## PRODUCT CHANGE NOTIFICATION

#PCN-DC-EDYZ-12

Business Unit	Product Line Code	Type of Change	Action	Date of issue
DC	AAA	Aesthetic	Notify Distributors and Field	11/19/2012

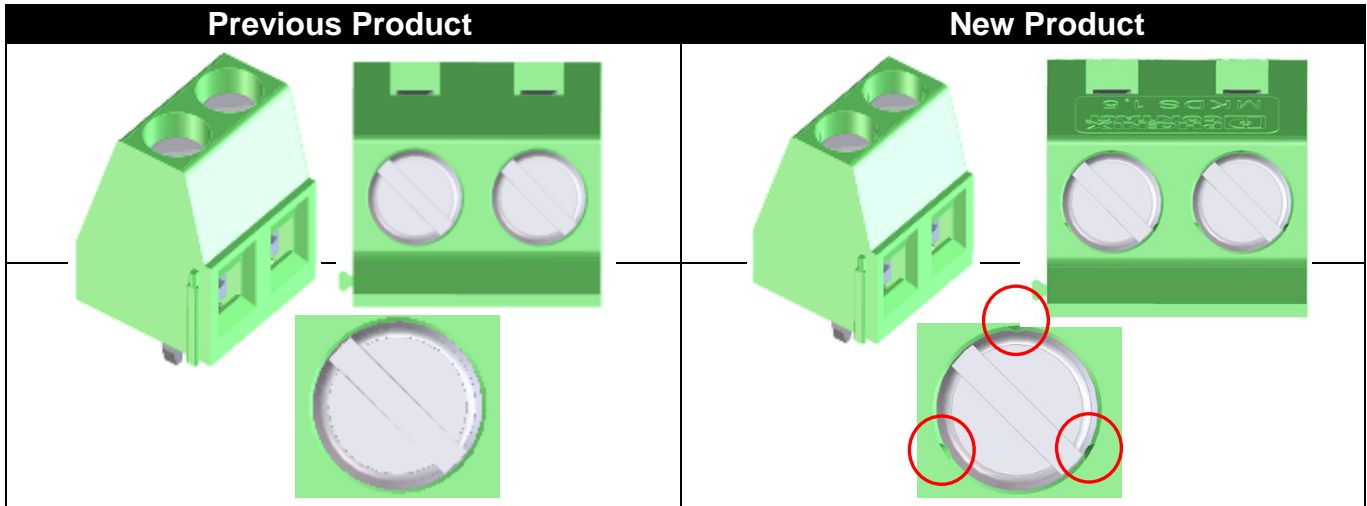
Due to our continuous improvement process the above mentioned articles will be delivered with an additional screw brake. Three plastic fins will be inserted in the screw shaft to prevent the closing of the clamping space during transportation. Dimensions and technical data remain the same. During the conversion period both versions will be delivered depending on the inventory.
